ADDENDUM NO. 3

**RE: NCDAC NC Correctional Institution for Women
Air Conditioning Installation
SCO ID#: 22-24913-02A
NCDAC Central Engineering Job Order # 4290**

DATE: September 12, 2023

1 SINGLE CELL B MECHANICAL PLAN
Scale: 1/8" = 1'-0"

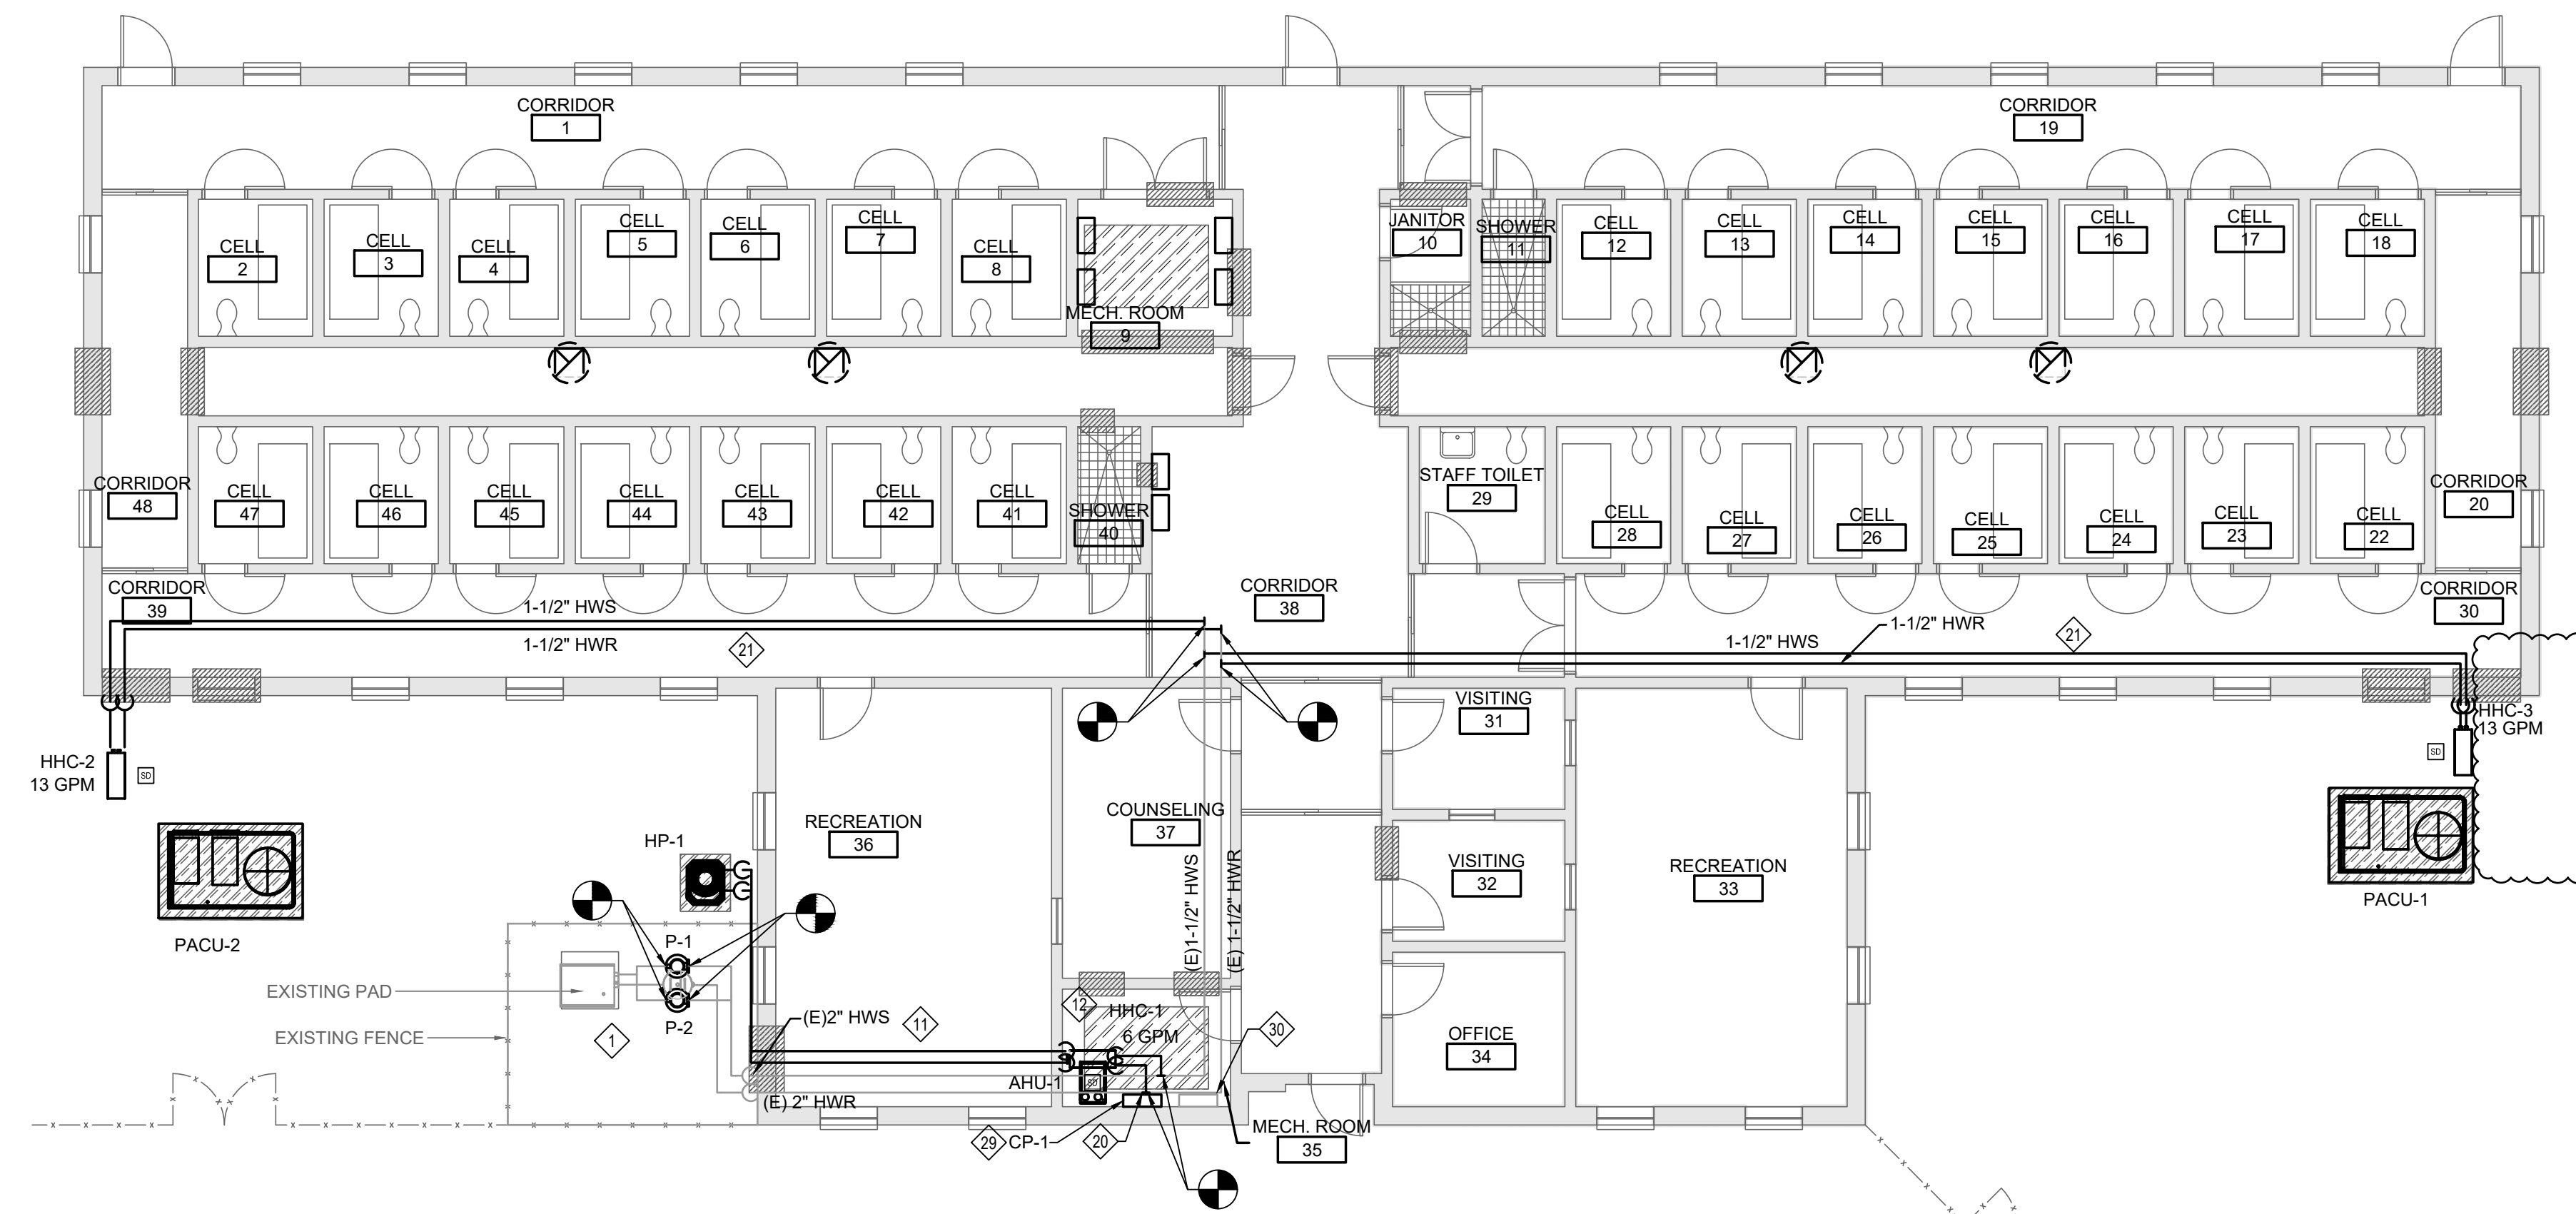
3. Sheet M141: See revision on attached sheet.
4. Sheet M200: Revised keyed note 1. See revision on attached sheet.
5. Sheet M210: Revised keyed note 1. See revisions on attached sheet.

1 DORMITORY N & O MECHANICAL ROOF PLAN
 Scale: 1/16" = 1'-0"

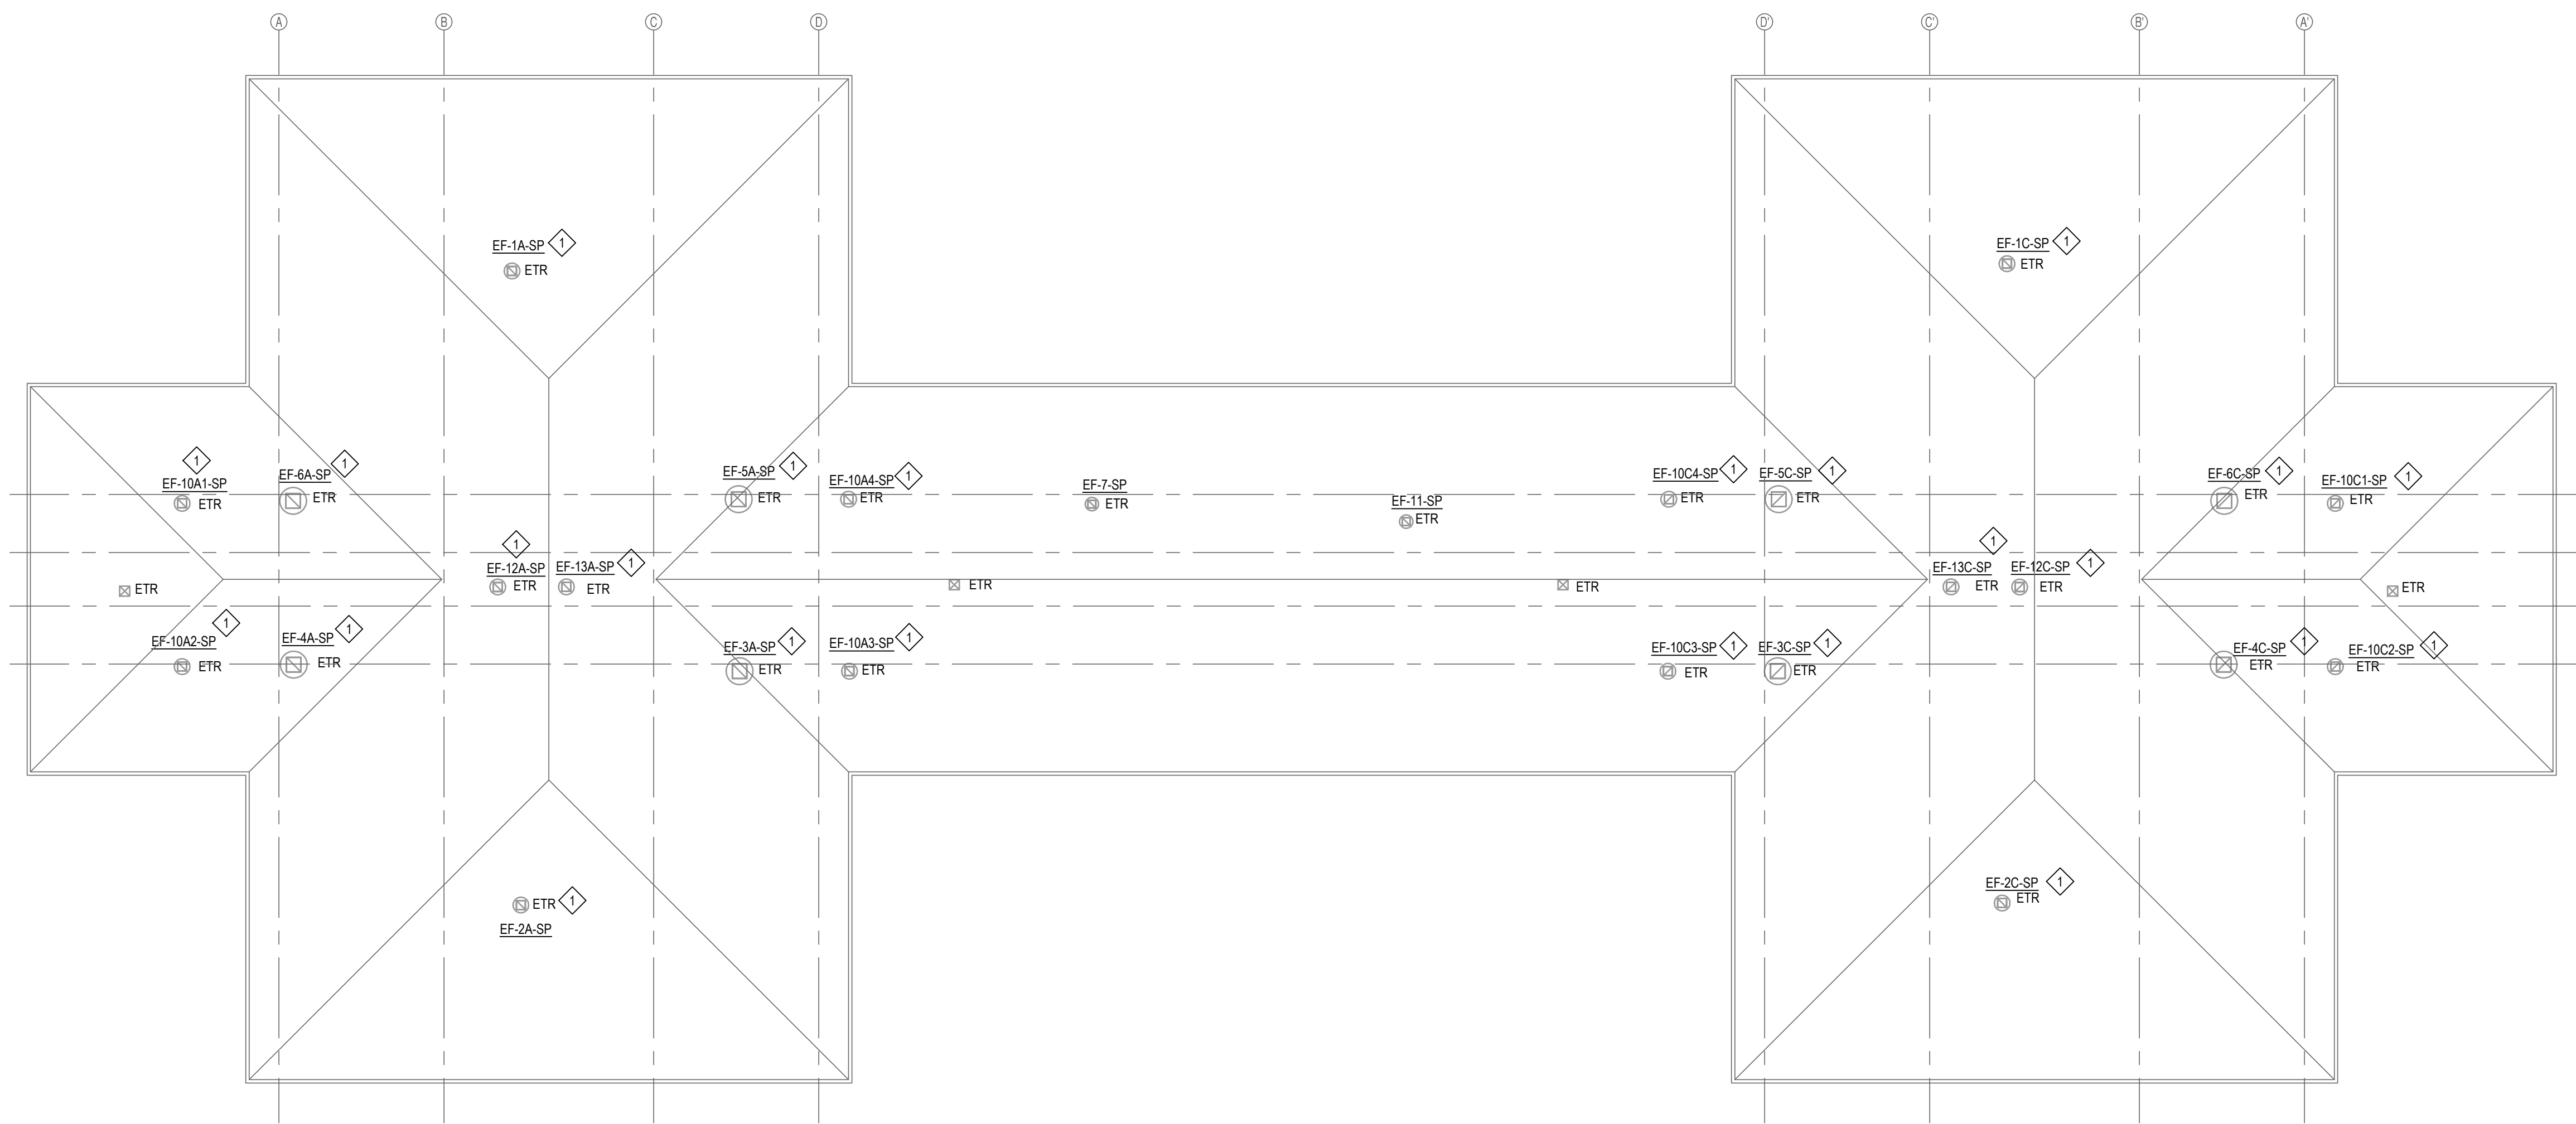
6. Sheet M220: Revised keyed note 1. See revision on attached sheet.
7. Sheet M401: Revised keyed note 6. See revisions on attached sheet.
8. Sheet M501: Revised ductwork detail. Exposed ductwork in dormitories shall be double wall insulated ductwork. See revision on attached sheet.

- BALANCE EXISTING FAN TO CFM INDICATED IN THE SCHEDULE. PROTECT EXISTING EQUIPMENT FROM DAMAGE. SERVICE AND ADJUST DAMPERS TO OPEN OR CLOSE FULLY (TWO-POSITION)
